AGENDA
Historic Yorktown Design Committee
Regular Meeting
York Hall – East Room - 301 Main Street
August 18, 2004
7:00 PM

MEMORANDUM

SUBJECT: Application No. HYDC-1-04; Duke of York Corporation

Photo # 4 – Proposed Shed - Front View

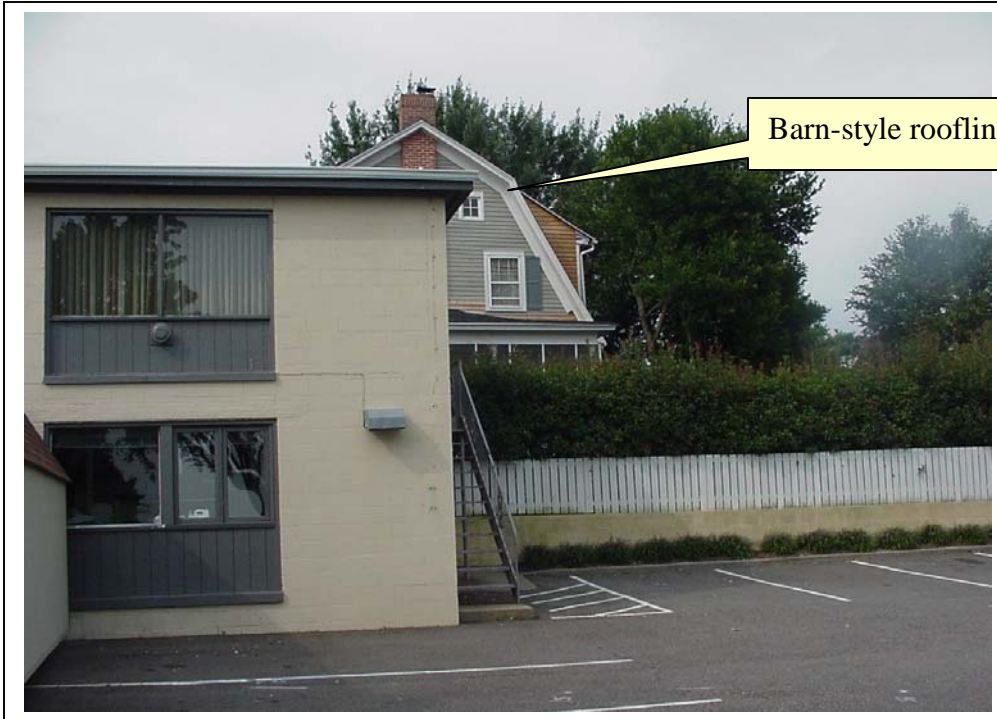
2. The Design Guidelines suggest that siding for commercial structures should be brick or painted wood clapboarding. The proposed storage shed is finished with a vertical-groove sheathing as opposed to the standard horizontal alignment of clapboard. The adjacent structure in the motel complex (the laundry/office) has a painted concrete block exterior with vertical-groove wood inserts under the windows. The adjacent building containing guest rooms has a painted brick exterior with vertical-groove wood inserts under the windows. The end of the main waterfront building in the motel complex is sided with horizontal alignment clapboard. At the Ballard Street end of the upper guest rooms building is a small addition that has a vertical-groove wood siding exterior. The adjacent residential structures along Church Street have wood clapboard exteriors (horizontal alignment). In summary, there are a variety of exterior finishes present on the existing motel complex buildings, some of which consist of a vertical-groove siding. While the Guidelines suggest that wood siding should be clapboard with a horizontal alignment, staff believes the vertical-groove exterior of the proposed shed would be compatible with the accent features used under the windows on the

adjacent buildings and the small structure on the Ballard Street end of the motel building. Staff believes the issue of siding is most important on the Church Street side of the structure. However, assuming that the 5-foot setback area will be landscaped with an appropriate evergreen shrub so as to obscure the view from Church Street and the adjacent house, staff believes that the vertical-groove siding could be found appropriate and consistent with the guideline indication that "...dependencies should have a design that is similar to and compatible with that of existing construction."

Based on the above noted observations, staff recommends that the application be approved subject to the trim being painted as discussed above.

Photo # 6 – Existing attached shed – Ballard Street end

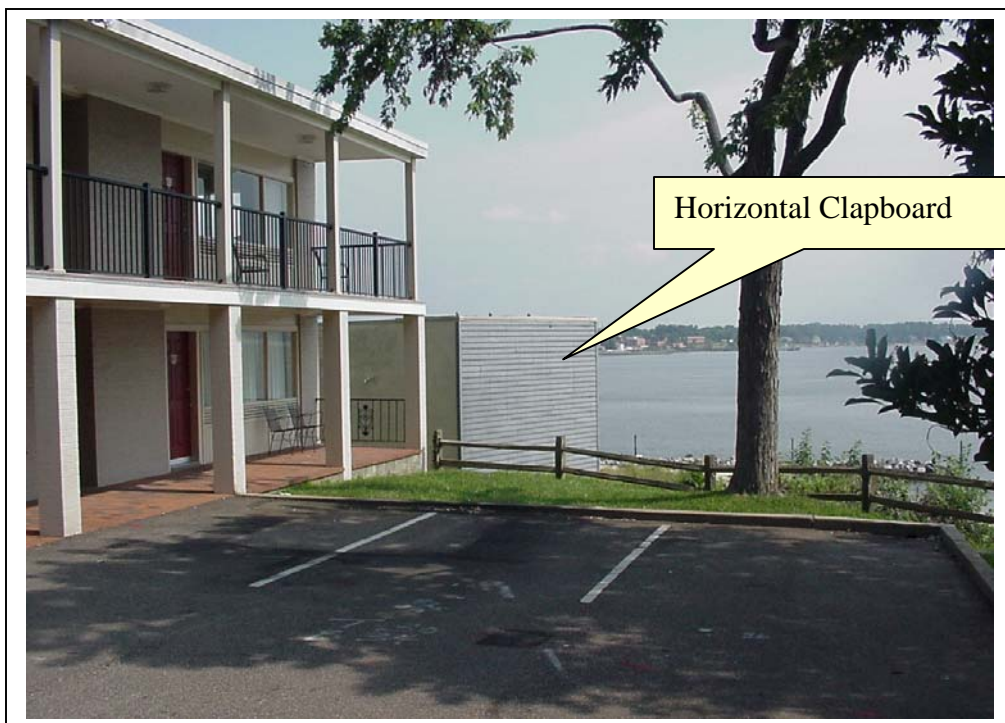
3. All of the buildings in the motel complex have flat roofs. The barn-style roof of the shed is generally compatible with the roofline of the residence located immediately behind the laundry building. Therefore, staff believes the roof shape is appropriate. The light brown shingles used on the roof are, in staff's opinion, compatible with the exterior paint color.
